FLYABILITY

ELIOS 3

October release notes

October 17th, 2023

Improvement in FlyAware™ mapping accuracy

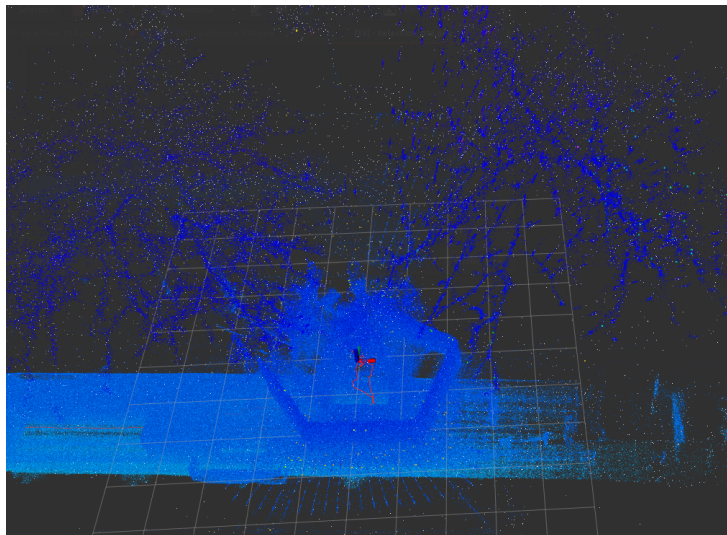
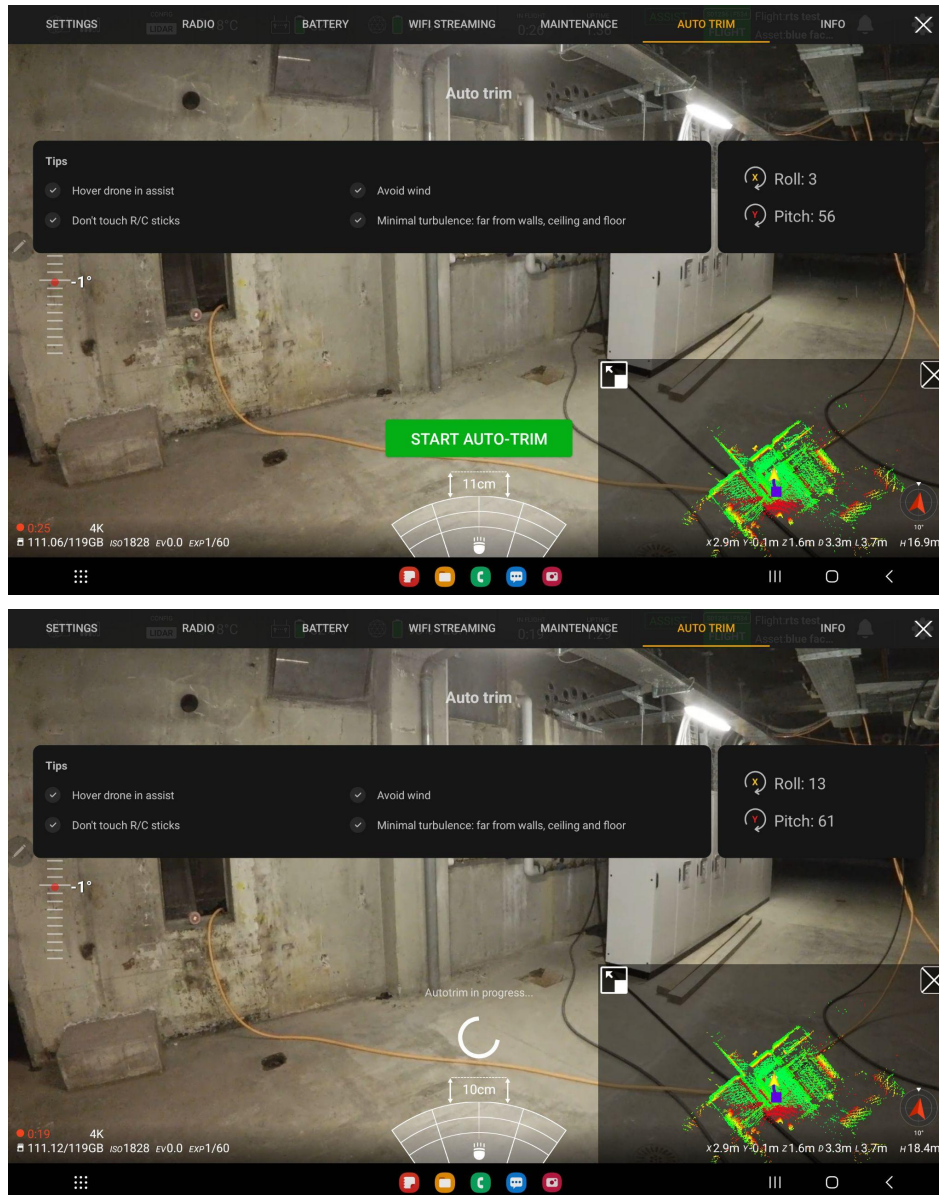
The improvement of the initialization process of the Elios 3 has resulted in an overall accuracy improvement, allowing for a reduction of at least 50% longitudinal drift in symmetrical environments. This translates to achieving up to 2.5% drift in challenging environments, as demonstrated in the example below.

Previous release : After flying back and forth in this tunnel, there is a drift of 14m, resulting in the hexagonal structure appearing twice in the map.

October release : There is no drift, the structure appears only once in the map.
